**MEMORANDUM**

SUBJECT: Zoning Commission Case No. 05-37B: **Final Report** for a Modification to an Approved Consolidated Planned Unit Development in Square 752 – Capitol Place

Approved Ground Floor

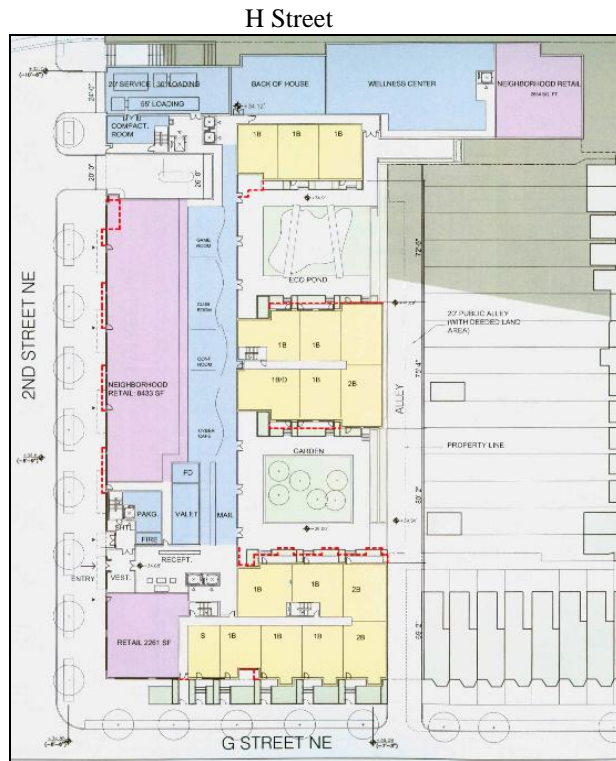
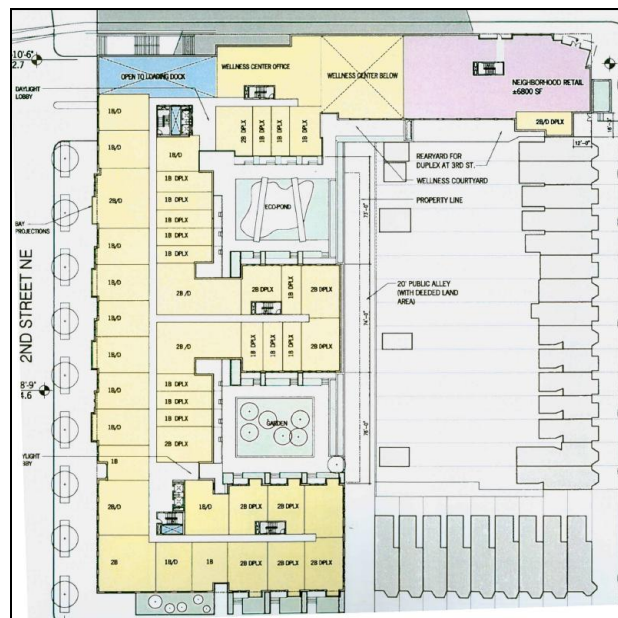
The project's retail use also has shifted slightly in location within the building. For example, the depth of retail space along the ground floor facing 2nd Street was thinned to provide space for tenant spaces (such as a club room, game room, and computer space) and to "pull retail back further from the residential uses on G Street" where two additional residential units were inserted. A small retail space between the parking garage entrance and the loading dock along 2nd Street was eliminated. Retail space was expanded along the second floor facing H Street. A professional office space on the building's third floor at the northwest corner of the site also was replaced with two residential units. OP does not object to the proposed changes which are limited in scope and generally retain stretches of retail along H and 2nd Streets.

The ground floor and second floor plans, as also provided in a larger scale on pages 27-28 of the Applicant's December 28, 2011 submission labeled "Comparative PUD Plans", would be most impacted by the modifications. Comparative copies of these existing and proposed floor plans are reproduced below. OP notes that the color pink represents commercial/retail, blue is service, yellow is residential, and green is garden.

estimate) with a likely location along 2nd Street. While OP does not generally object to the requested flexibility in retail gross floor area or the inclusion of a management/leasing office in the project, OP encourages the Applicant to address at the hearing how both retail flexibility requests would not overly interrupt the supply or spirit of the project's commitment to neighborhood serving retail.
